Engineering Change Notice(ECN)

ECN-D-2603-07

(L-axis Cover Design Improvement)

NINEBELL	설계 변경 요청서(ECR) (Engineering Change Request)			Customer	ACM
				ECR No.	ECR-A-2406-04

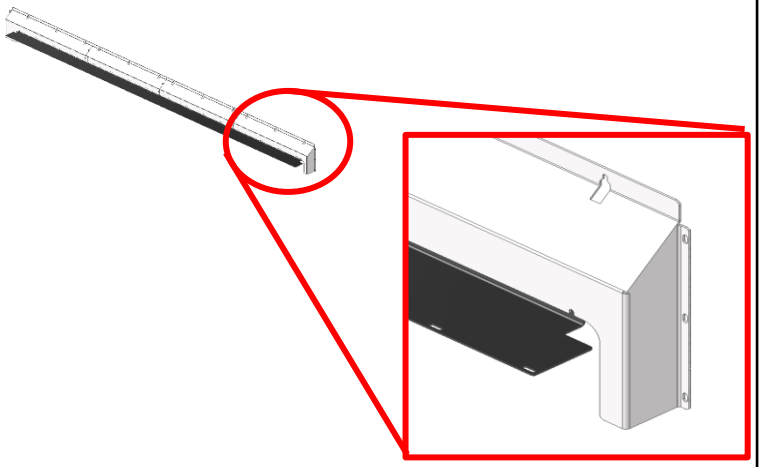
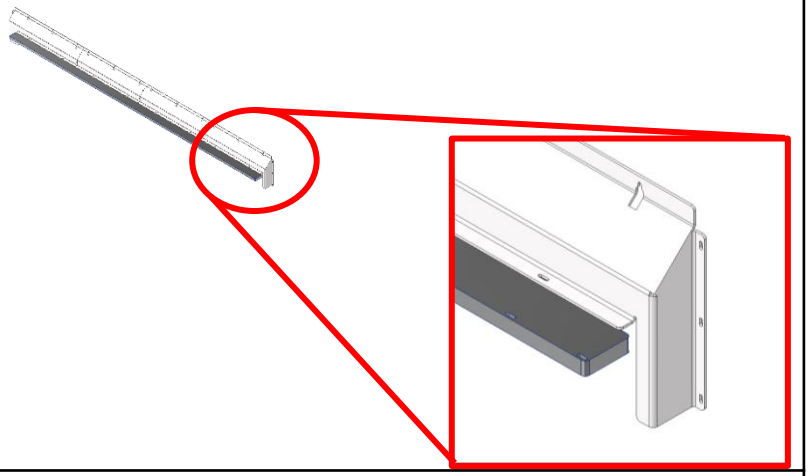
Before(Problems and Change Requests)	After(Expected Effect)
Problems: the Process L-axis cover disengages when stepped on **Request:** 1.change the structer or choose higher strength materials. **Reason:** 1.Due to the requirement of frequent entry into the machine for maintenance, the support plate should be designed as a structure with sufficient strength to support the weight of two adults.  fig.1	1.the support plate should be designed as a structure with sufficient strength to support the weight of two adults.

전체 이미지 Full Image	 ※변경 위치 혹은 관련 위치 표시 ※Show changes or related positions

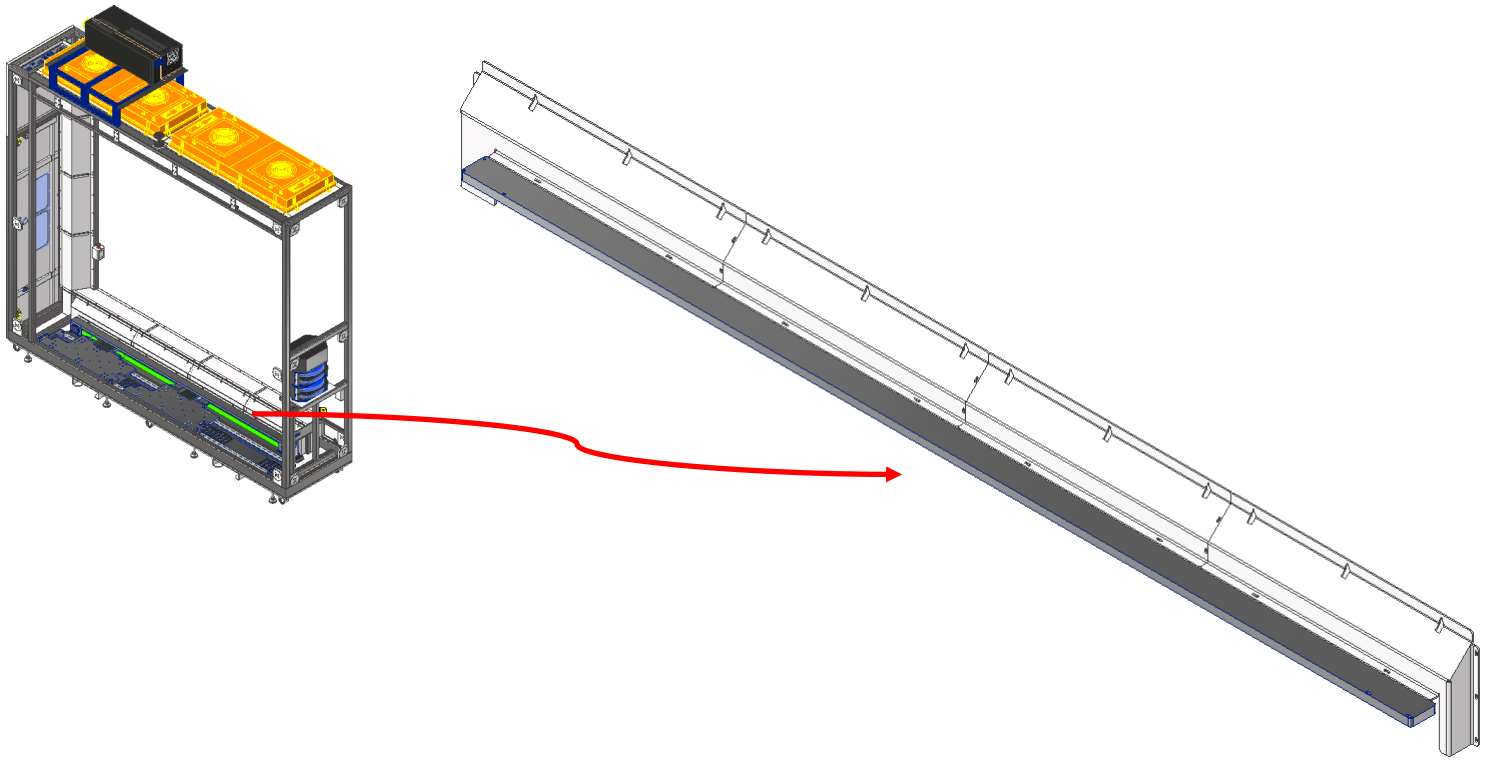
적용 장비 타입 Applicable project type	11CH-S-SB,12CH-HIZ-SB-L3 PROCESS [328-21383, 328-21487]	적용 범위 Scope	■ 신규 발주분 (New order) □ 기발주분 (Previous order) ■ 기출하장비 (Existing shipped equipment)
변경 사유 Reason for change	■ 고객 요청 (Customer request) ■ 품질개선 (Quality improve) □ 원가절감 (Cost reduction) □ 생산성 향상 (Increase productivity) □ 부품 단종 (Part discontinuation) □ 기타 (ETC)	ECR NO.	ECR-S-2603-09
		ECN NO.	ECN-D-2603-07
변경 상세 사유 Detailed reason for change	the Process L-axis cover disengages when stepped on		
변경 사항 Changes	변경 전(Before)	변경 후(After)

상세내용 Detail	Deflection of the support plate under the weight of an adult	Structural and material modifications were implemented to suppress deflection under a two-adult load

Part No.		
Before	→	After
CM24P-L000-P003-1	→	CM30P-L000-M001-0
CM24P-F110-P008-0	→	CM30P-F110-P005-0
CM24P-F110-P005-0	→	CM30P-F110-P006-0
CM24P-F110-P007-0	→	CM30P-F110-P007-0
